# STAFF REPORT FOR THE PLANNING COMMISSION MEETING OF DECEMBER 15, 2020

**FILE NO**: LU-2020-0045 **AGENDA ITEM**: E.1

**AGENDA TITLE:** For Possible Action: Discussion and possible action regarding a request for a Special Use Permit to allow alternative compliance of the Downtown Mixed-Use Standards, specifically standards related to a mixed use requirement, a community amenity requirement, the sidewalk specification, and building envelope step-back requirements relative to a multi-family residential development on property zoned Downtown Mixed-Use (DT-MU), located at 906 South Stewart Street, APNs 004-055-02, and -07. (Hope Sullivan, hsullivan@carson.org)

Figure 9: Sidewalk Sections (complete set of sections included on attached site plan)

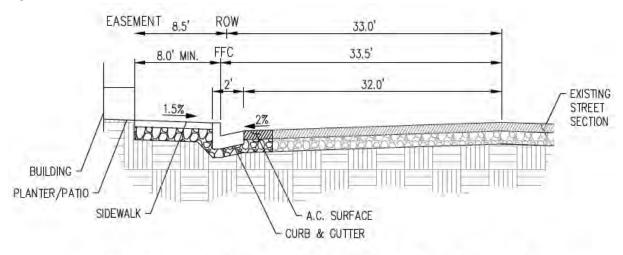
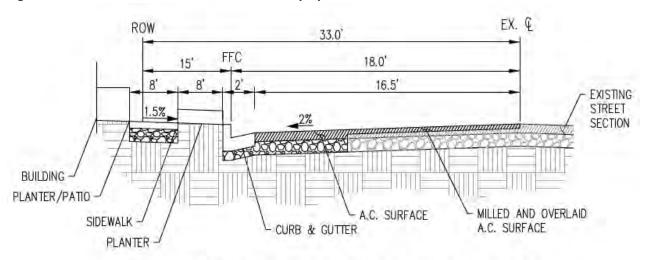
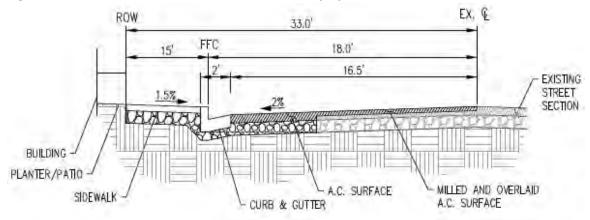
As the development is on a commercial corridor as opposed to a residential street, a 15-foot sidewalk with street trees should be provided. The applicant is proposing an 8-foot wide sidewalk along Stewart Street with a planter or patio between the sidewalk and the building. Along East 9<sup>th</sup> Street, the applicant is proposing an 8-foot wide sidewalk with a planter between the sidewalk and the curb, and a 15-foot wide sidewalk with a planter between the building and the sidewalk.

The sidewalk design is also a part of creating an inviting, pedestrian friendly environment. Staff acknowledges that this particular site will connect to a 4.5-foot wide sidewalk along Stewart Street to the south that is not in the DTMU district. The applicant also proposes to add the street furniture, and utilize the downtown streetlights, which will create continuity with the downtown area and an inviting environment. Therefore, given the location of the sidewalk coupled with the inclusion of the downtown streetlights and street furniture, staff finds the request will be consistent with the Master Plan.

STAFF RESPONSE: The applicant is proposing an 8 foot wide sidewalk on Stewart Street, and a varying sidewalk width along 9<sup>th</sup> Street that is either 8 feet wide or 15 feet wide. Along Stewart Street, the applicant proposes a planter or a patio between the building and the sidewalk. Along East 9<sup>th</sup> Street, the applicant proposes varying planters with some between the curb and the sidewalk and others between the building and the sidewalk. The applicant also proposes to install street furniture, specifically benches.
